PART VI | COMPARISON DRAWINGS

107 HIGH STREET, LINDFIELD, HAYWARDS HEATH, RH16 2HR

**PART VII | PROPOSED REGULARISATION
OF SCHEME**

PROPOSED REGULARISATION OF SCHEME
SUMMARY

PROPOSED WEST ELEVATION. 1:50@A3

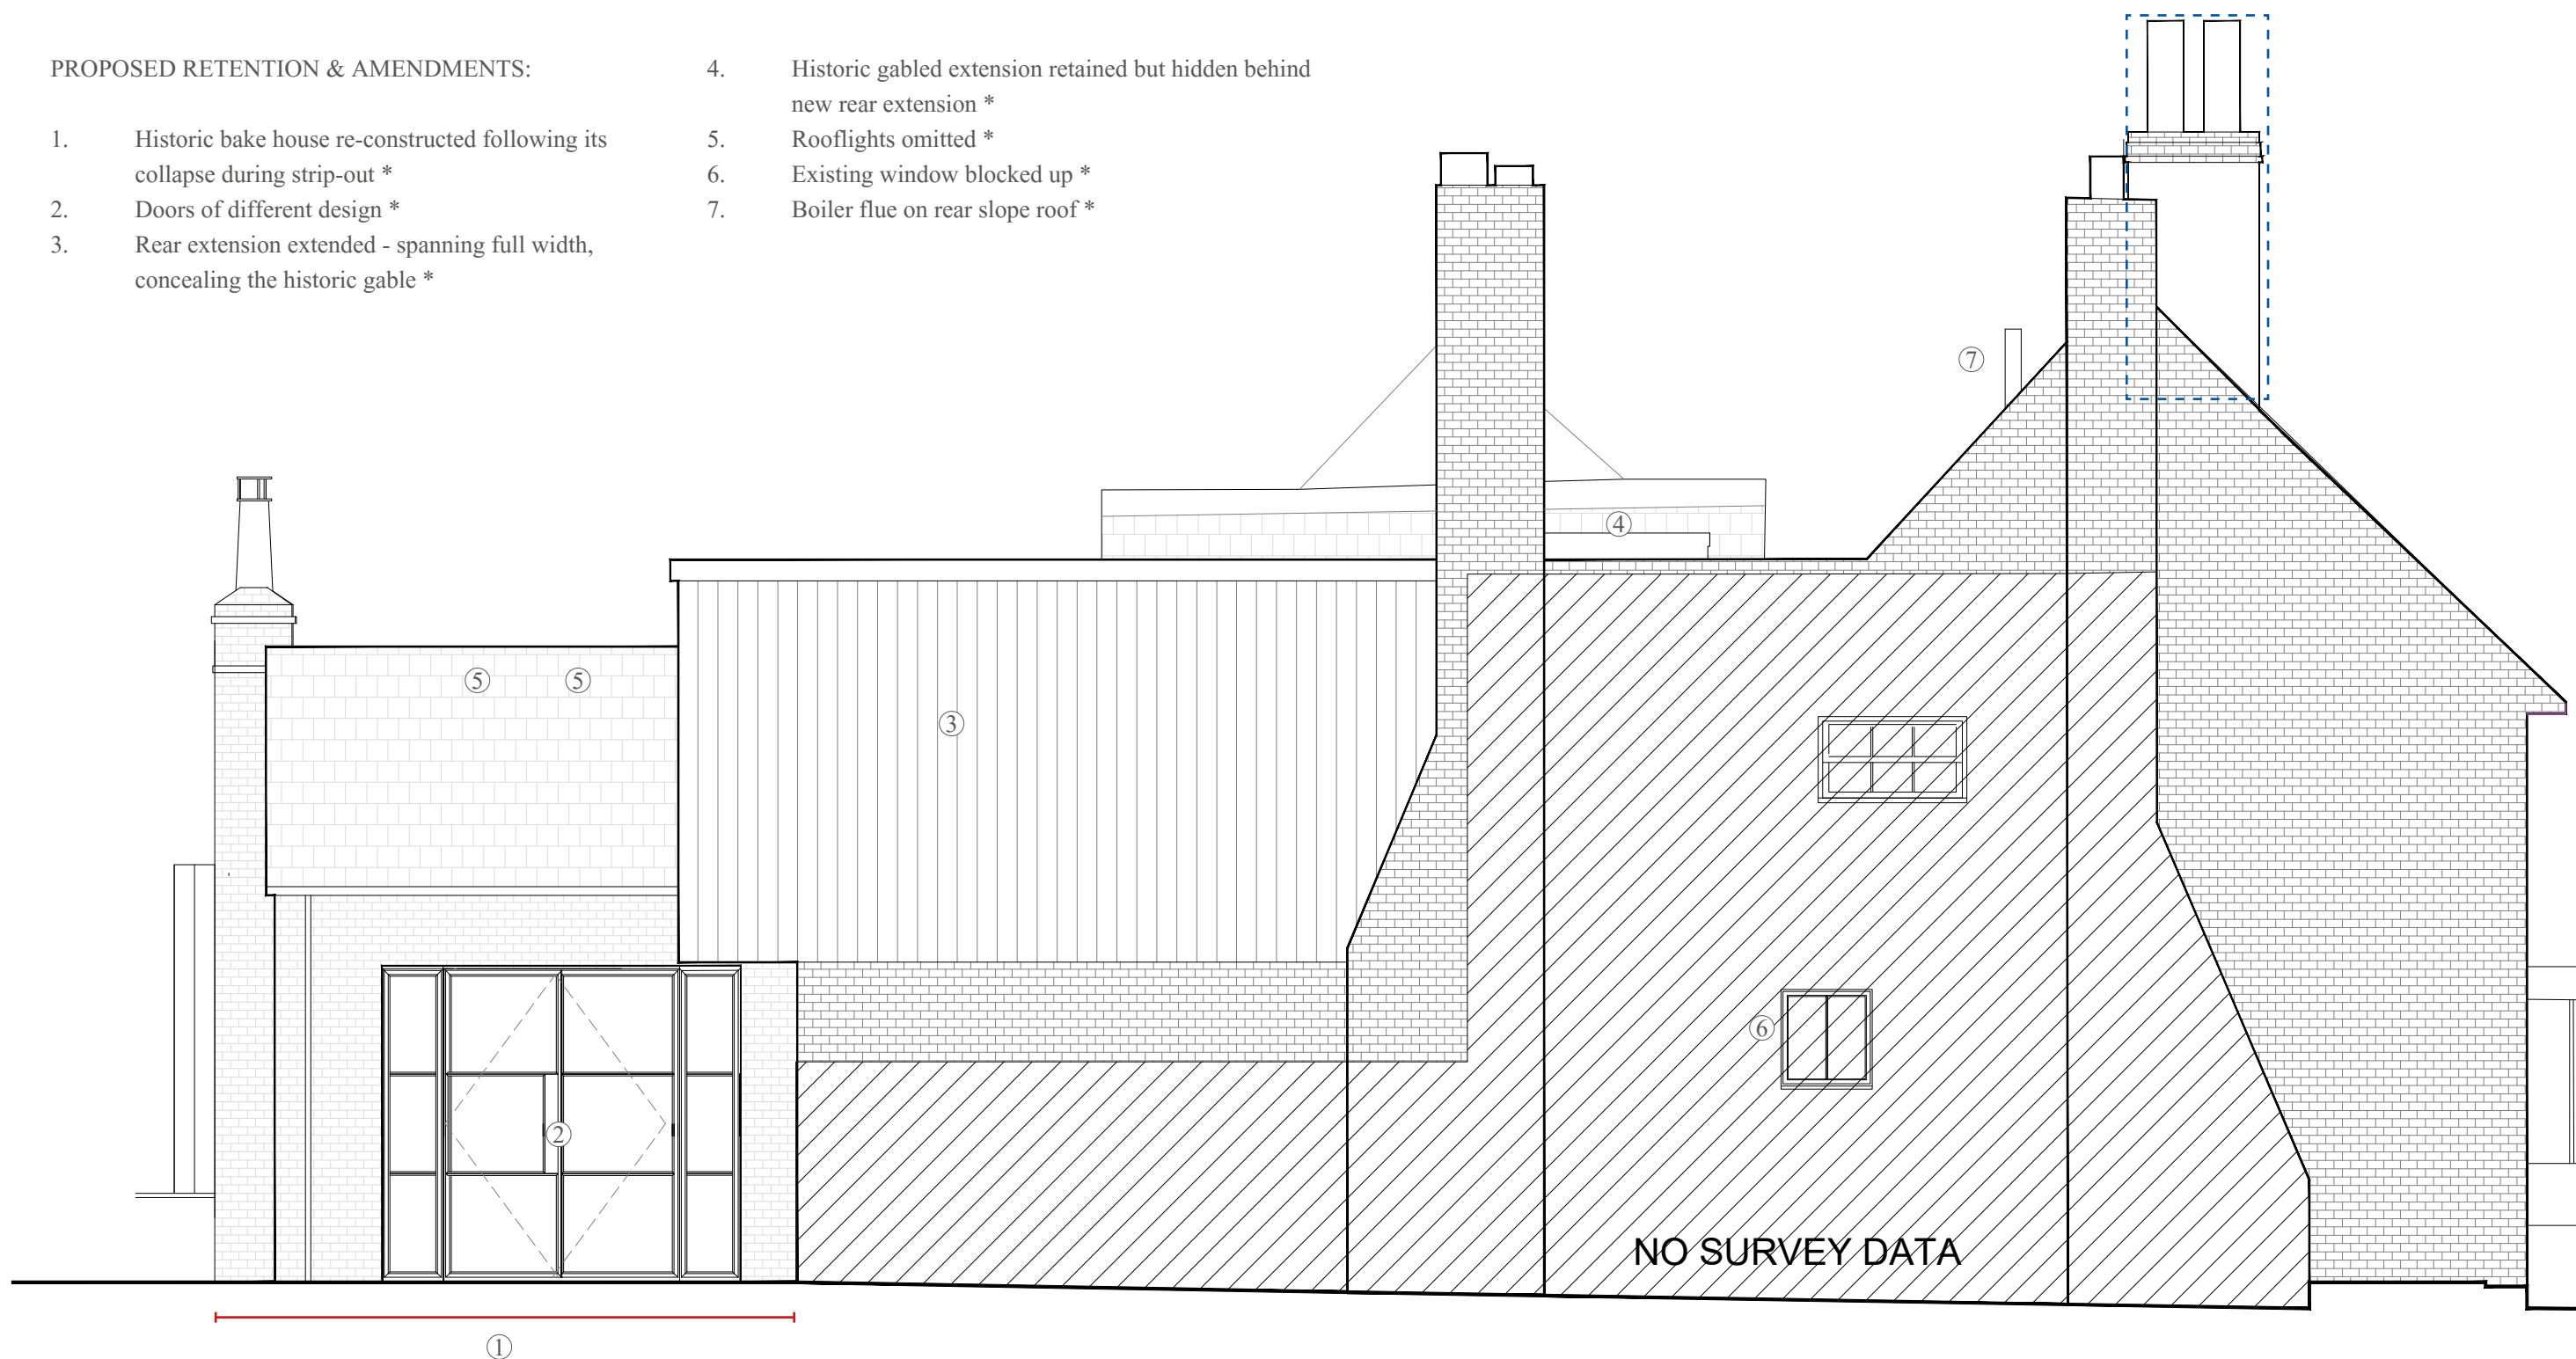
1. Historic bake house re-constructed following its collapse during strip-out *
2. Window of different design *
3. Raised planter not constructed *
4. Gutter design deviates from approved- parapet wall and secret gutter *
5. Flat roof infill*
6. Rear extension extended - spanning full width, concealing the historic gable *
7. Terrace balustrade glazed instead of metal *
8. Historic gabled extension retained but hidden behind new rear extension
9. Gothic window retained but hidden behind new rear extension wall
10. Rooflights omitted *
11. Landscape design deviates from approved *
12. AC AHU louvred timber enclosure - matching timber of new extension *
13. Existing chimney removed *
14. Boiler flue on rear slope roof *

PROPOSED SOUTH ELEVATION. 1:50@A3

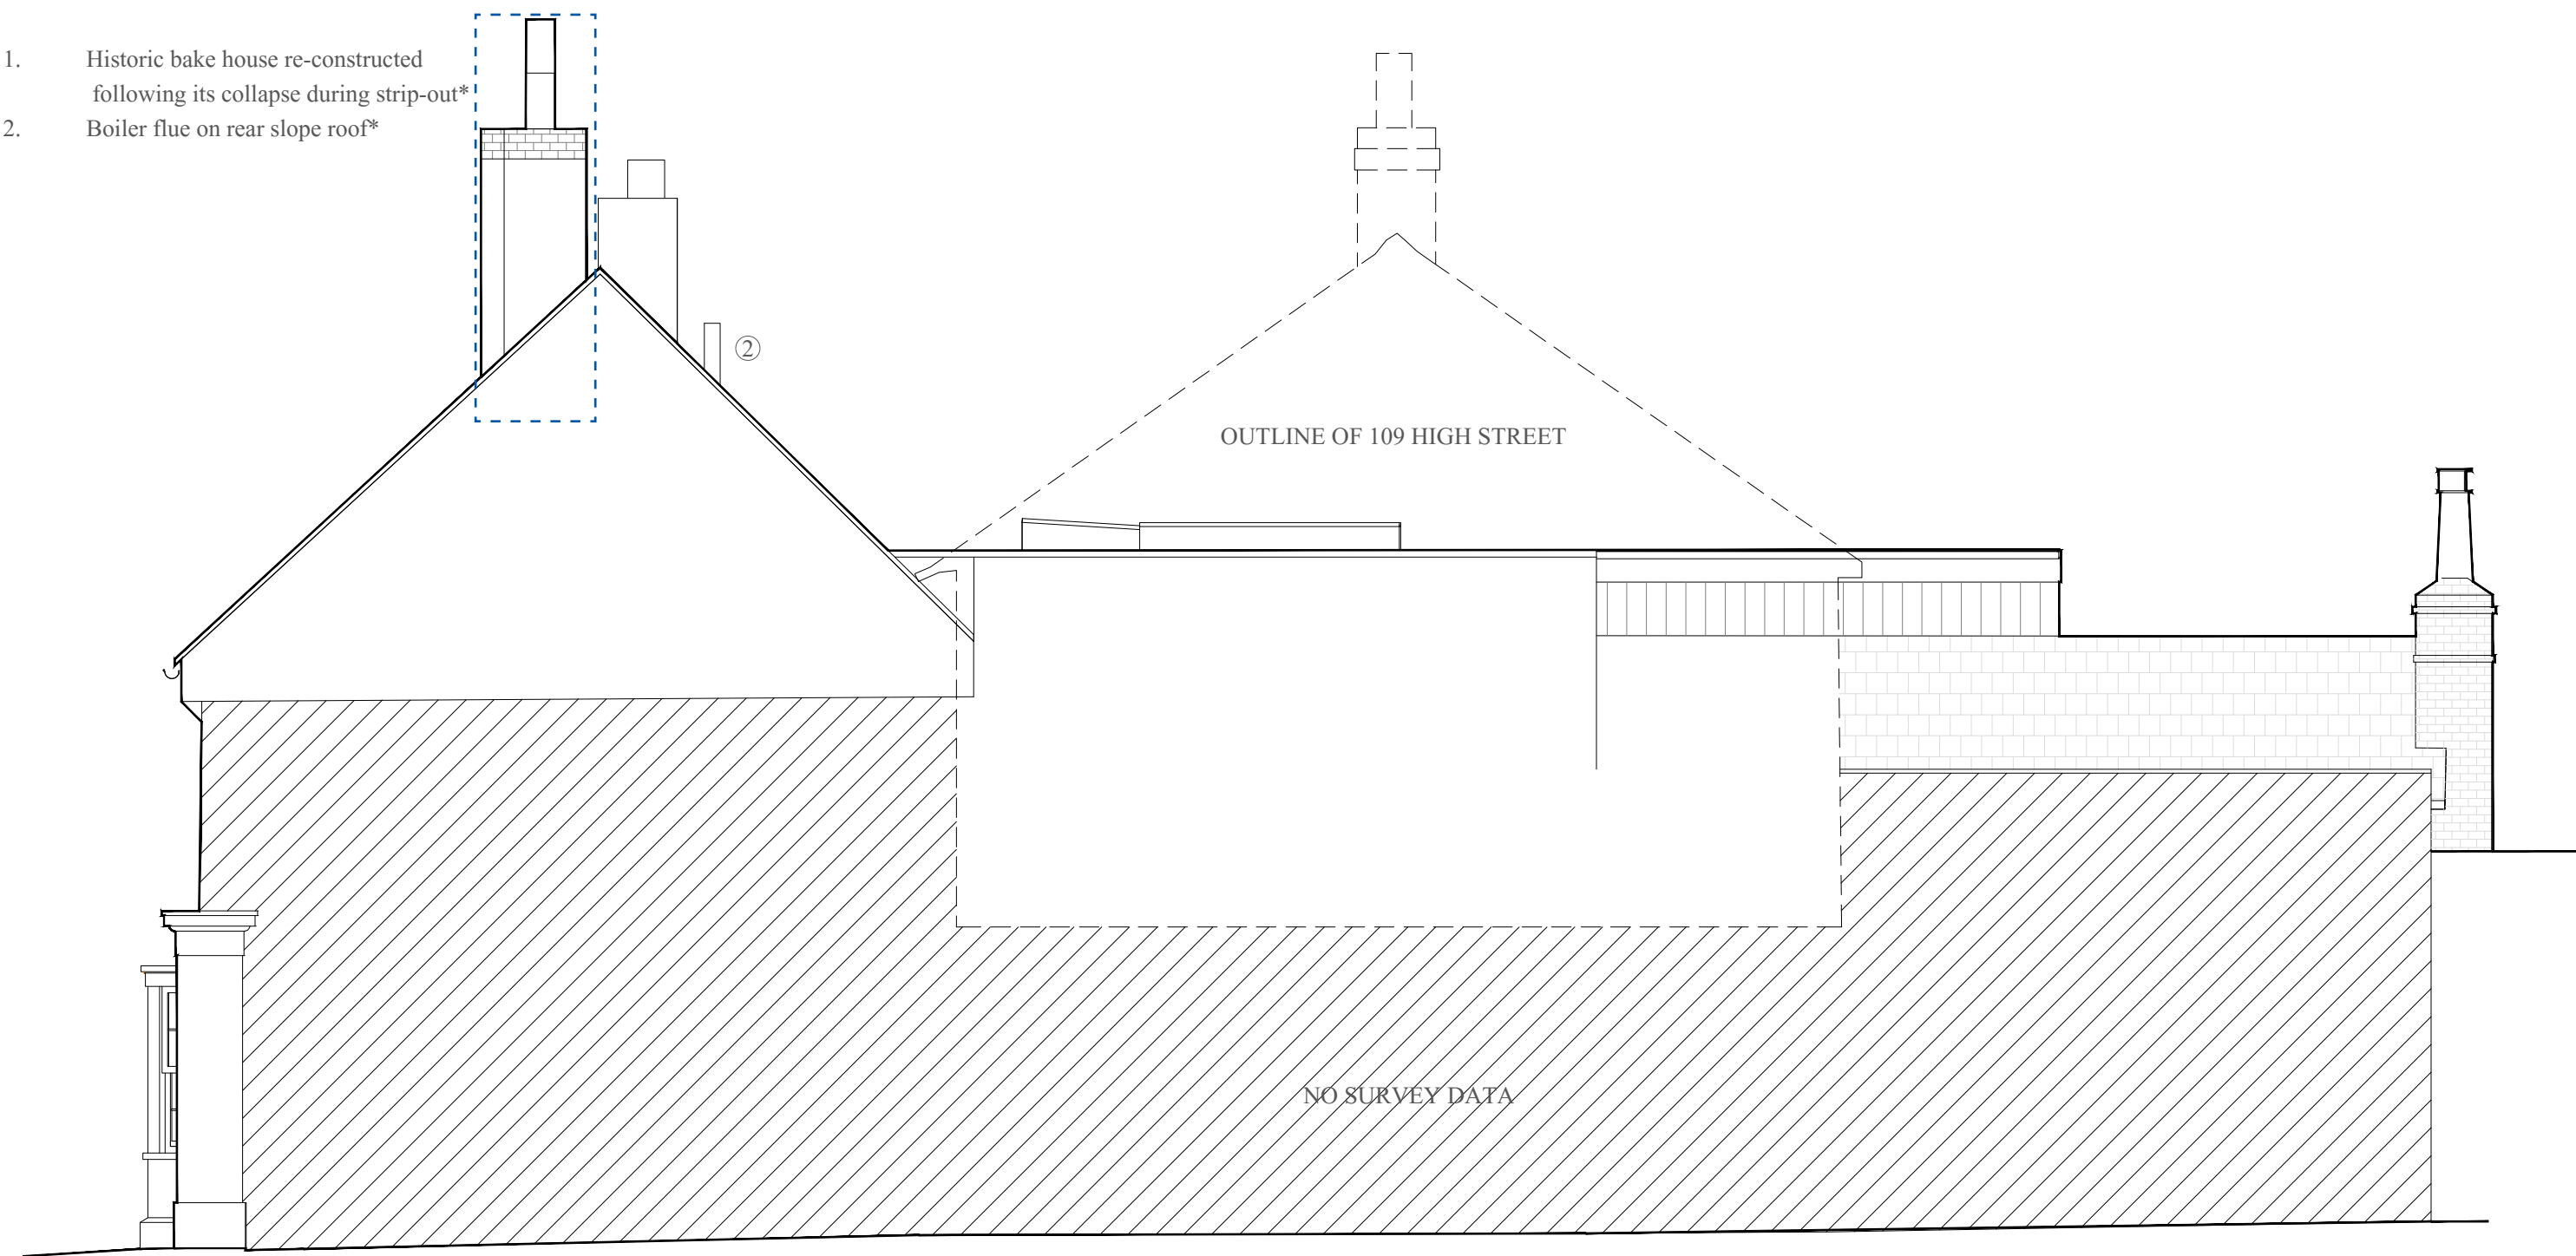
1. Historic bake house re-constructed following its collapse during strip-out *
2. Doors of different design *
3. Rear extension extended - spanning full width, concealing the historic gable *

4. Historic gabled extension retained but hidden behind new rear extension *
5. Rooflights omitted *
6. Existing window blocked up *
7. Boiler flue on rear slope roof *

PROPOSED SECTIONAL ELEVATION AA REV A. 1:50@A3

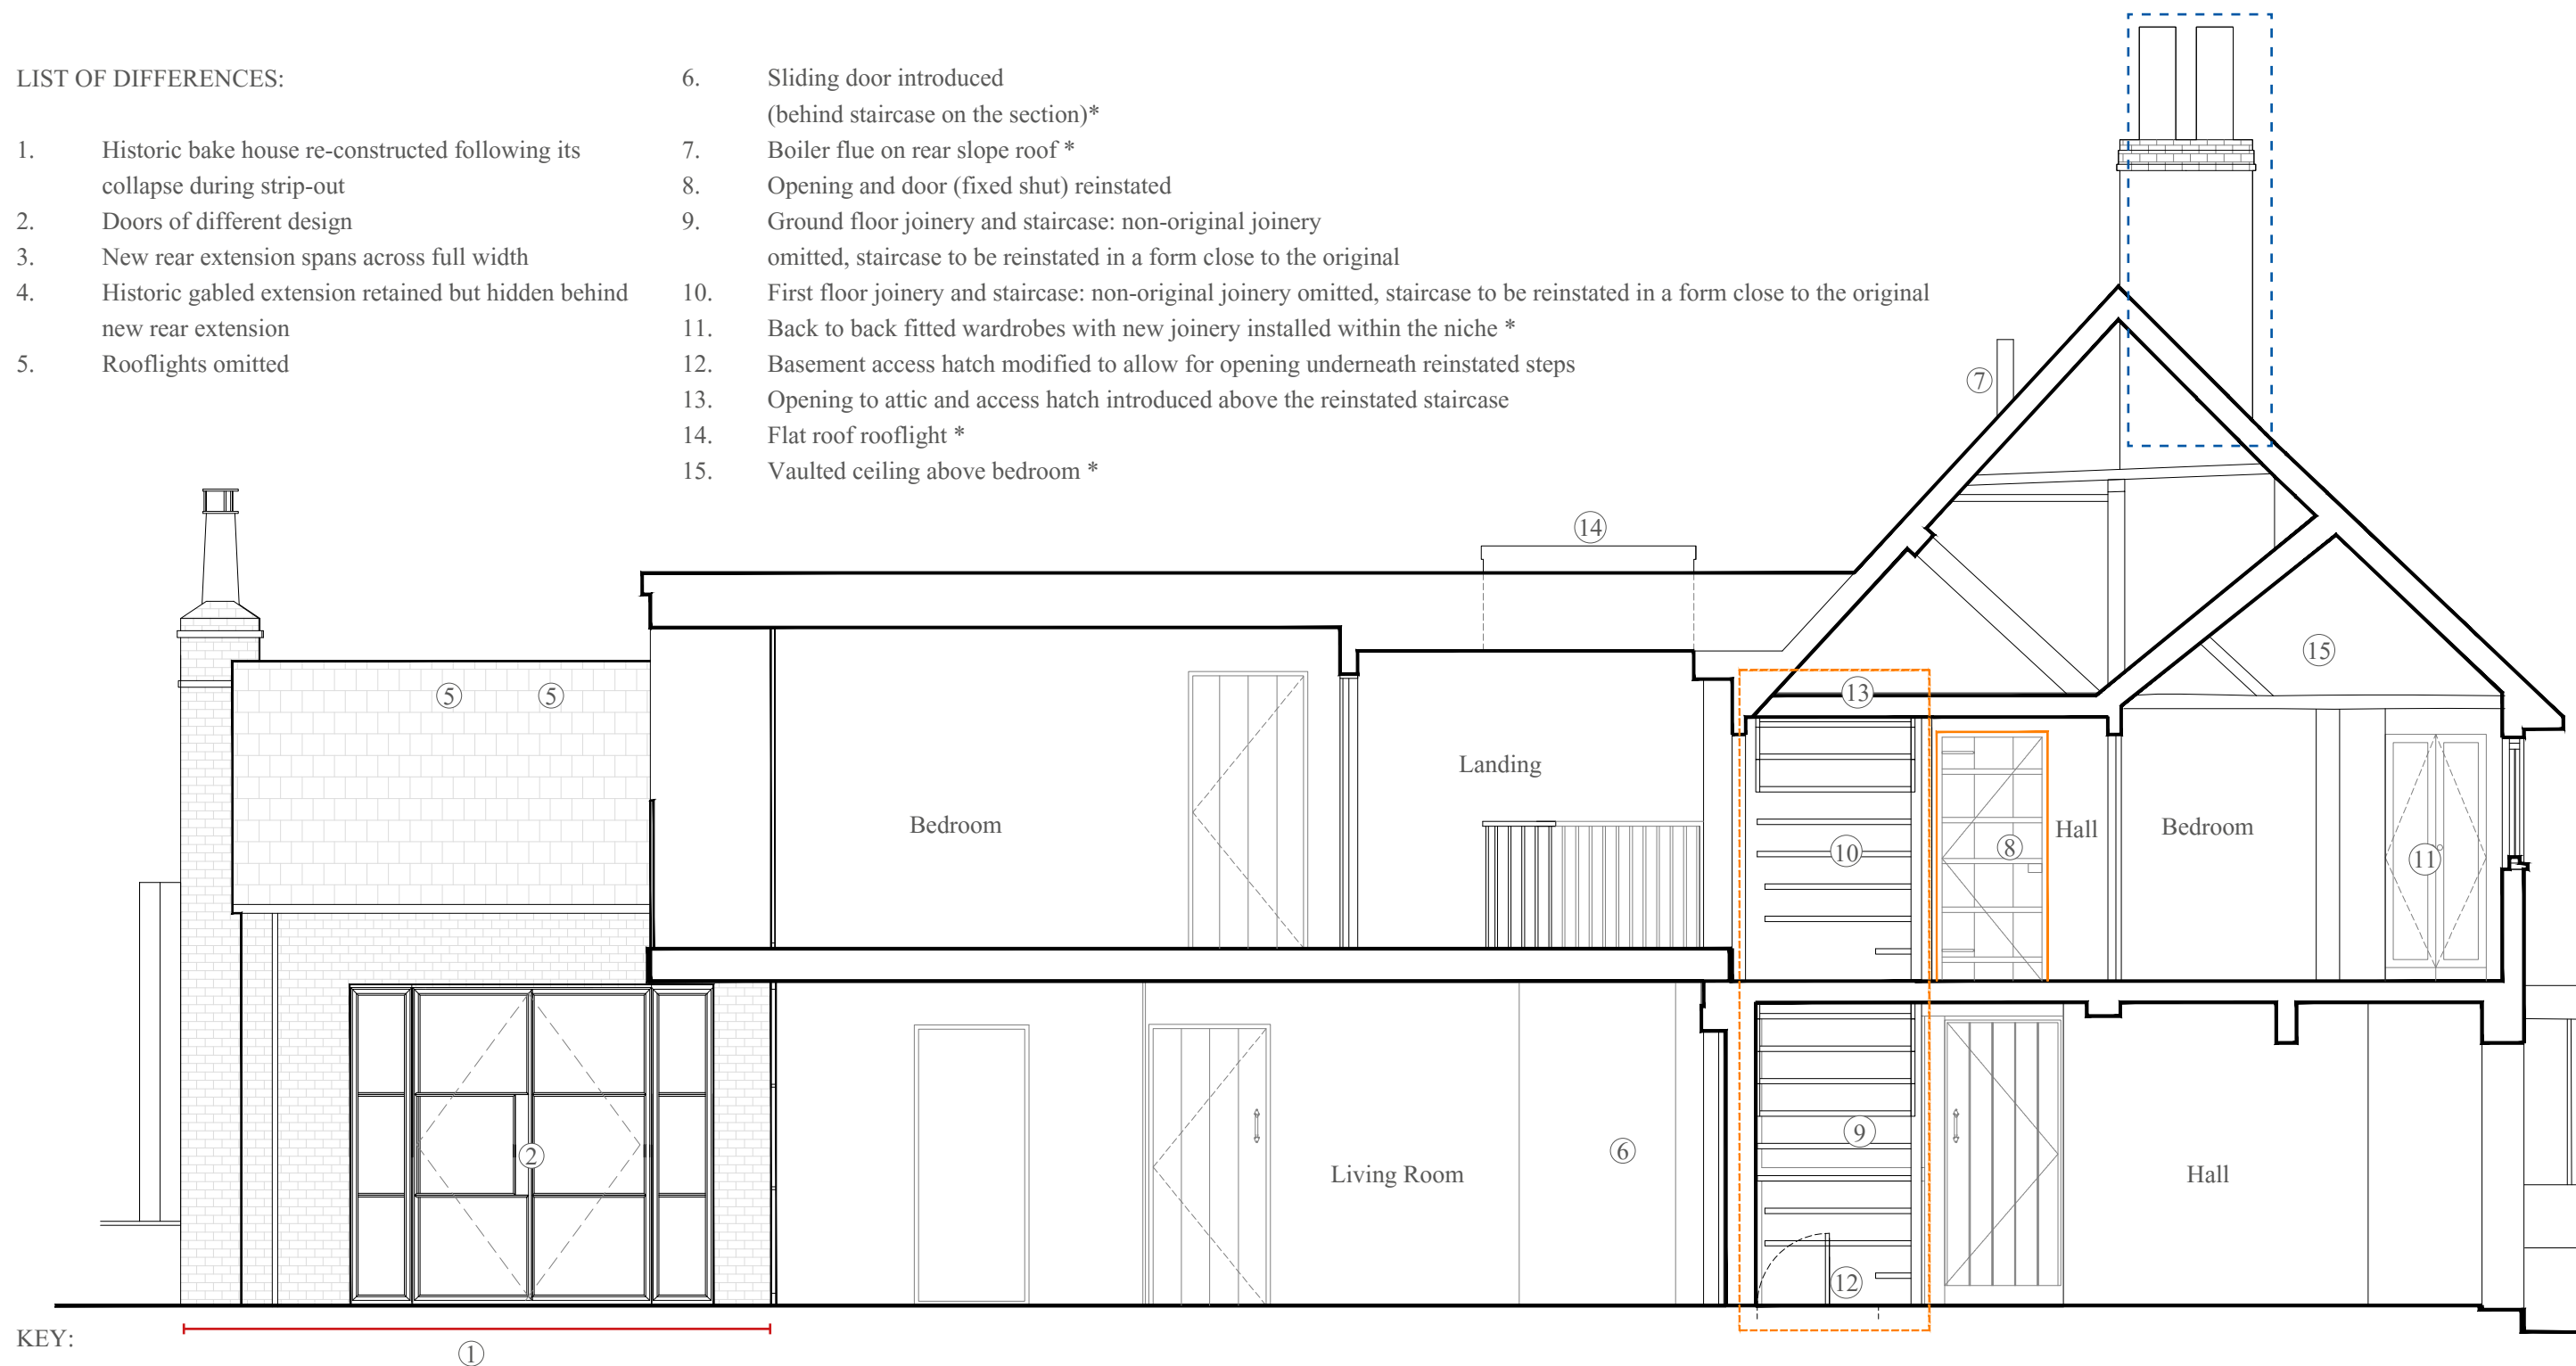
| 1. Historic bake house re-constructed following its collapse during strip-out | 6. Sliding door introduced (behind staircase on the section)* |
| 2. Doors of different design | 7. Boiler flue on rear slope roof * |
| 3. New rear extension spans across full width | 8. Opening and door (fixed shut) reinstated |
| 4. Historic gabled extension retained but hidden behind new rear extension | 9. Ground floor joinery and staircase: non-original joinery omitted, staircase to be reinstated in a form close to the original |
| 5. Rooflights omitted | 10. First floor joinery and staircase: non-original joinery omitted, staircase to be reinstated in a form close to the original |
| | 11. Back to back fitted wardrobes with new joinery installed within the niche * |
| | 12. Basement access hatch modified to allow for opening underneath reinstated steps |
| | 13. Opening to attic and access hatch introduced above the reinstated staircase |
| | 14. Flat roof rooflight * |
| | 15. Vaulted ceiling above bedroom * |
